**PUD &
SUBDIVISION STAFF REPORT**

Date: April 3, 2003

DEVELOPMENT NAME Heron Lakes Subdivision, Phase Two, "Corrected Plat",
Resubdivision of Lots 110, 111, and 112.

SITE PLAN

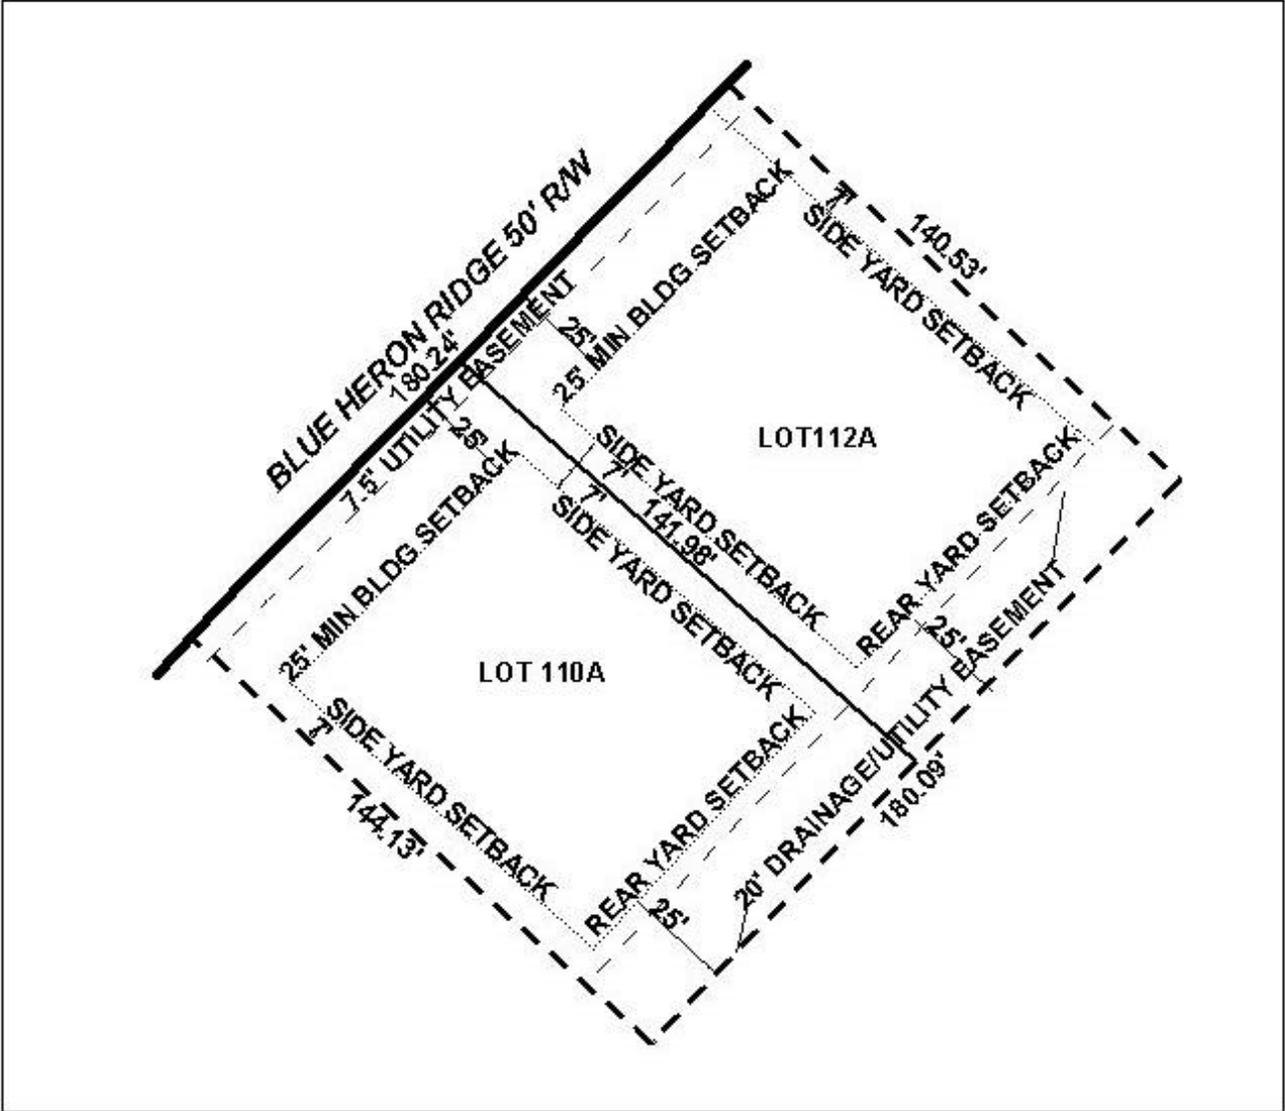
The plat as submitted reflects reduced side yard setbacks; and based on the building limits as
shown, appears to increase site coverage above 35%. However, a subsequent discussion with the
engineer about the specifics of the original PUD approval (reduced setbacks applied only to lots
less than 65' in width and the 35% maximum site coverage was not changed) found that reduced
setbacks and increased site coverage were not needed since the proposed lots would be
approximately 90' x 141', or 12,690 sq.ft.. Therefore, a revised plan without the reduced
setbacks or building limits should be submitted for the file, and the reduced setbacks or building
limits should be removed from the final plat.

Subdivision: With minor modifications, the plat meets the minimum requirements of the Subdivision Regulations and is recommended for Tentative Approval subject to the following conditions: 1) reduced setbacks or building limits be removed for the final plat; and 2) placement of the 25' minimum building setback line on the final plat.
